**ADDENDUM NO. 1
TENDER NO. 87-20
BANWELL IMPROVEMENT PROJECT PHASE 1**

**BANWELL ROAD CORRIDOR IMPROVEMENTS
PHASE 1 - TECUMSEH ROAD TO PALMETTO ST.**

SK-1

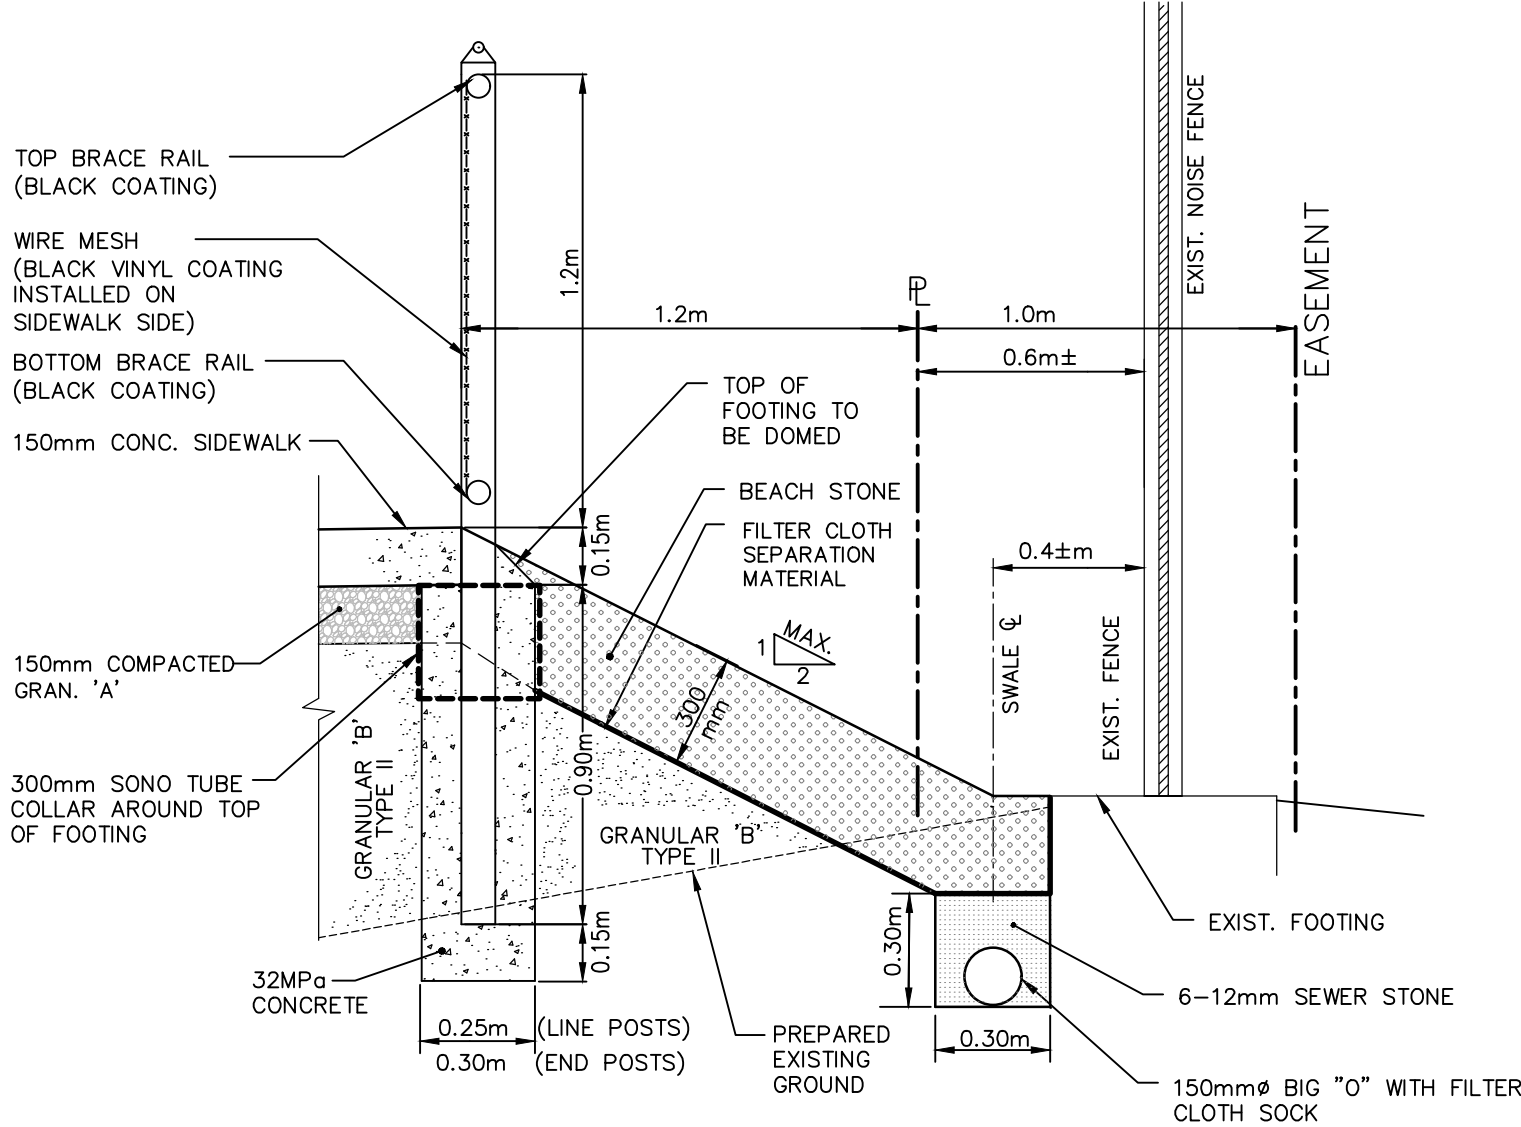
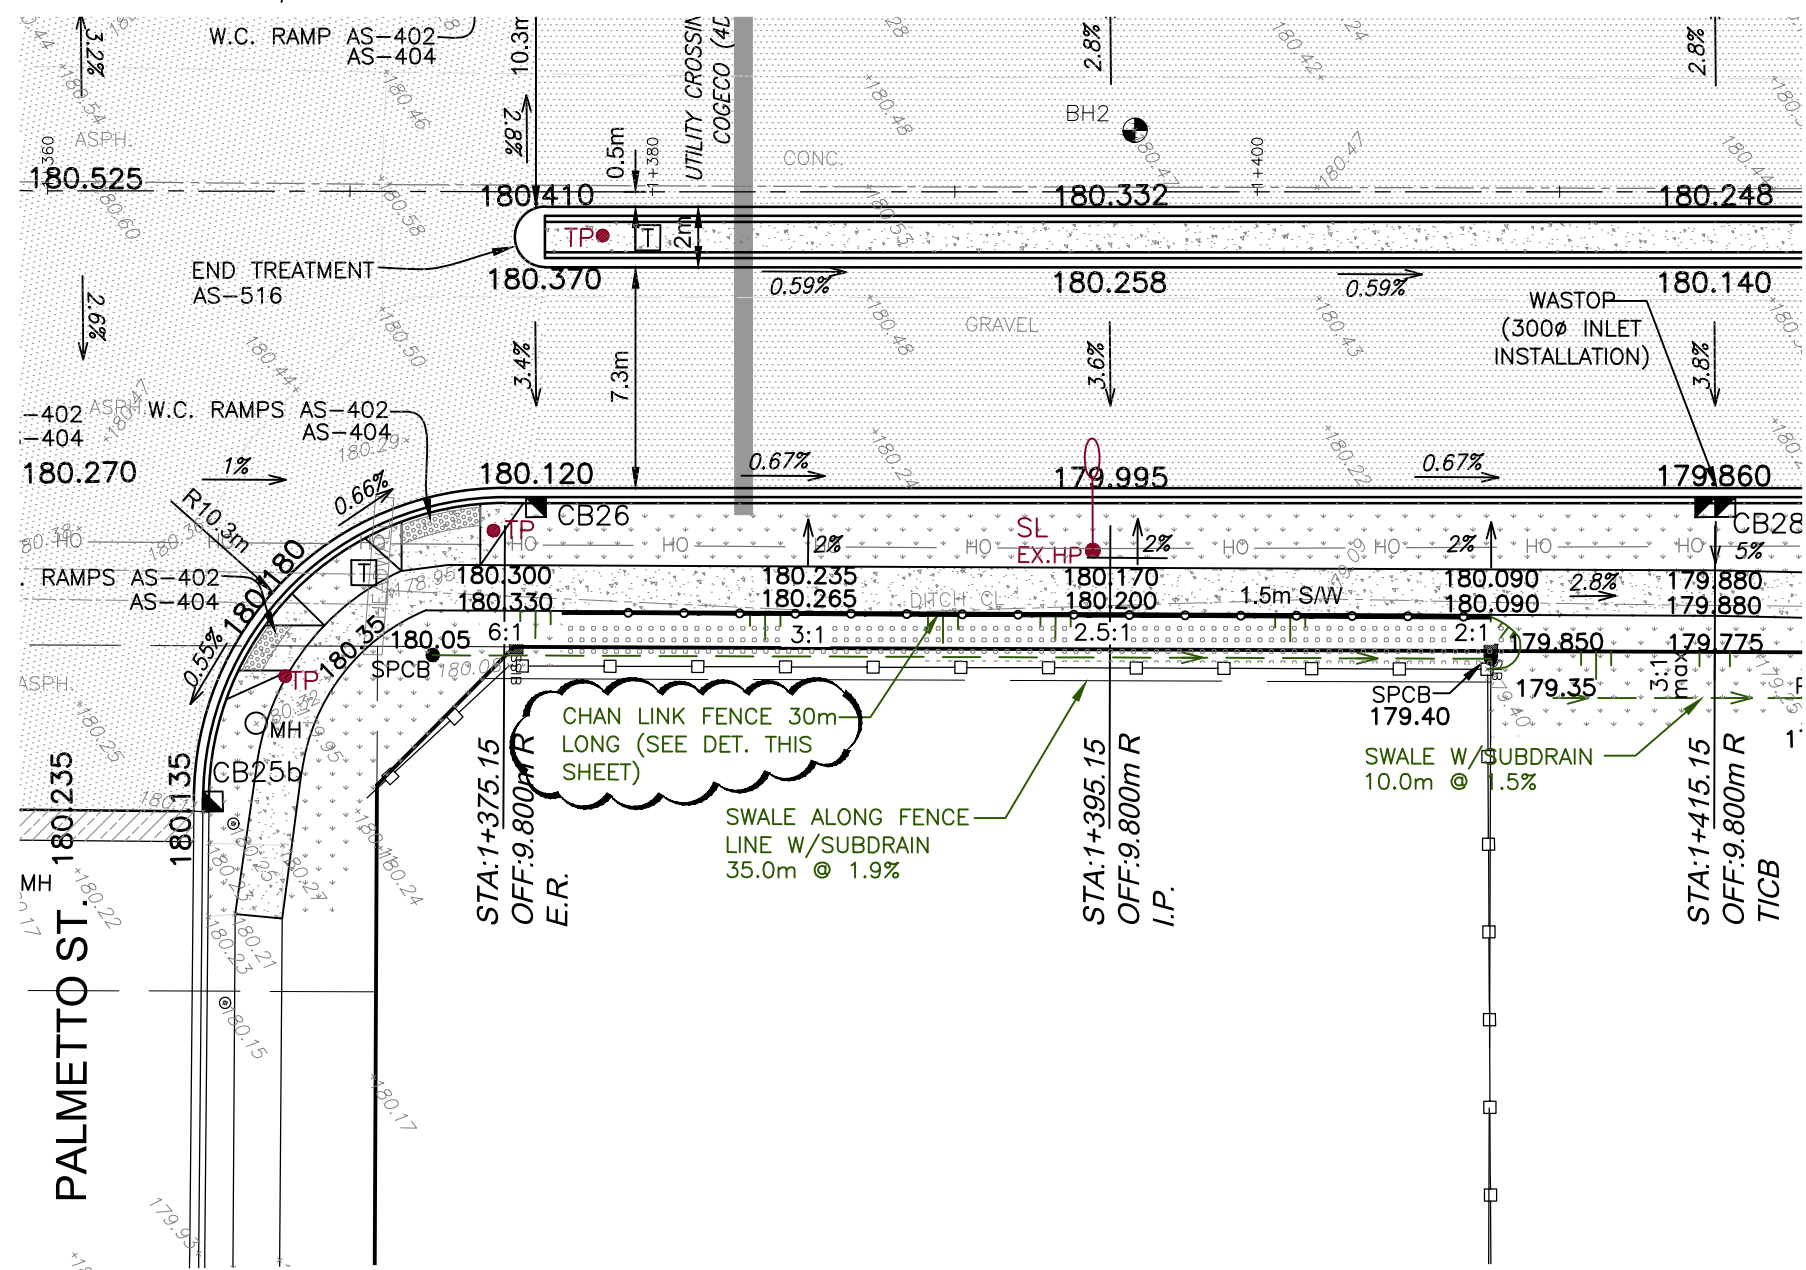
See attached revised sheet BF-12 and SK-1 detail.

ITEM NO.	SPEC PROV	DESCRIPTION	ESTIMATED QUANTITY	UNITS	UNIT PRICE	TOTAL AMOUNT
10	S.P.15	Supply and maintain Engineer's site office.	1	L.S.		\$ -
*11		Supply and install 1.2m vinyl-coated chain link fence and side slope as per detail SK-1 Note: Price to include beach stone, filtercloth, granular backfill, concrete footing and Big "O" as per detail.	30	L.M.		\$ -
12		Strip and clean ditch of all organic material and supply and place approved engineering clay for ditch infill. Compact clay in 300mm layers.	250	C.M.		\$ -
13		Construct temporary granular access for BMR and Shell as shown on the detail Sheet 31. Strip topsoil (vacant lot 3155 Banwell) and leave in a berm shape for future maintenance. Supply, place and compact approximately 1200 Tonnes (minimum 600mm thick) Granular "B" Type II Virgin, access road. On project completion salvage granular access road and stockpile on the lot.	1	L.S.		\$ -
